# UNITED STATES PATENT AND TRADEMARK OFFICE

## Office Action Summary

10/019,556

GOTTE, JOHANNES

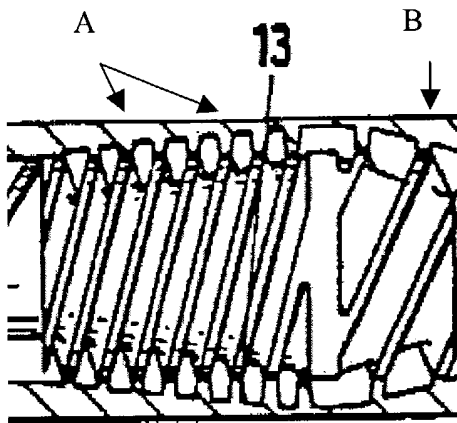
Capelle teaches the claimed apparatus having an extruder with an inlet (3), outlet bore (4), jacket (2), spindle (6), plasticizing zone (13), the jacket thread and the

spindle thread cross section change linearly (A) and (B) in the zone in a complementary manners. See Figure Below.

In regards to claim 3, this feature of the 10-20% and 80-90% of the free total cross sections appears to be taught at point (B). While, the drawings may not be considered as exact scale, the general progression of the threads cross section and dimensions give a general idea that the inlet to outlet cross sections changes.
